R. McConnell Group PLLC

Seven buildings at Kearns and Bonanza

What the City's own record shows about parking, traffic and height

Comment on behalf of twenty-two neighboring businesses · Public hearing and possible final action, October 14, 2026

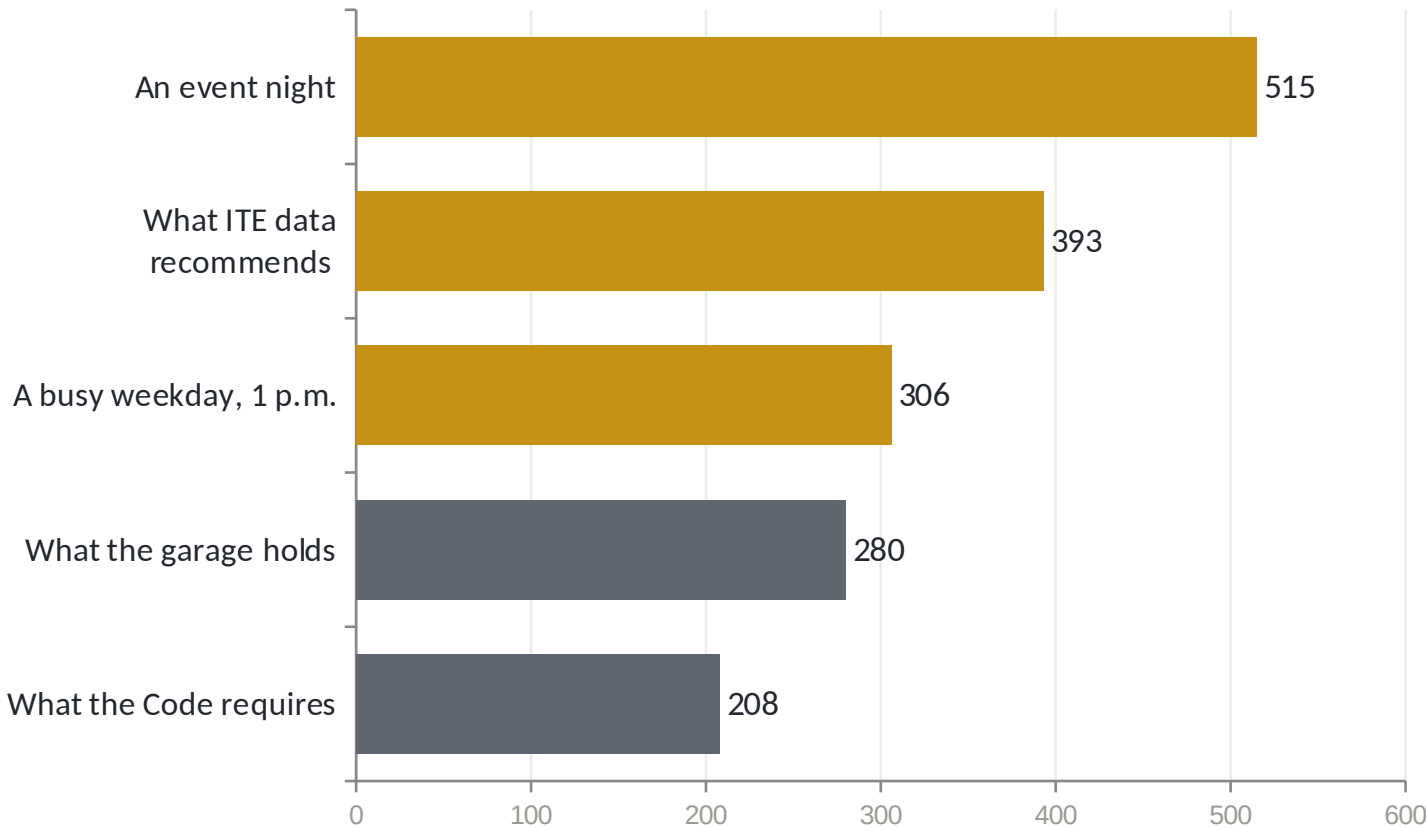
The City reports a surplus. The applicant's engineer reports a 235-space shortfall.

“This demand is 235 parking spaces greater than the proposed capacity of 280 stalls.”

Both documents sit in the same packet. This record states the Code requirement five ways: 165, 180, 208, 209, 210. § 15-6-6(A) requires a finding that the project complies with the Code. No finding can rest on five different numbers.

Kearns Boulevard at Bonanza Drive, a Thursday at about 2:30 p.m. A member of the public filed it with the City on August 30, 2026.

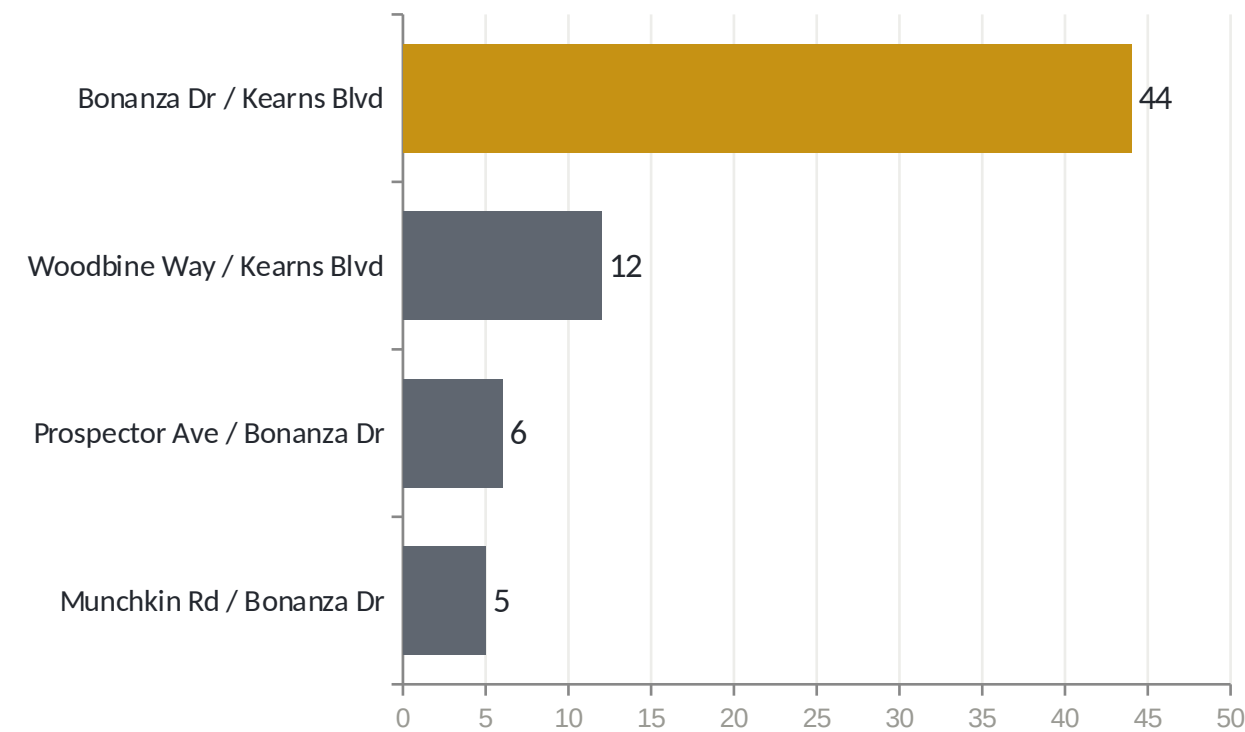
The traffic study never counted the hour school lets out.

The study did not count the major intersections. The City supplied those counts from a Friday in February 2024. The high school releases its students hours before the afternoon analysis hour. No finding under § 15-6-6(P) can rest on it.
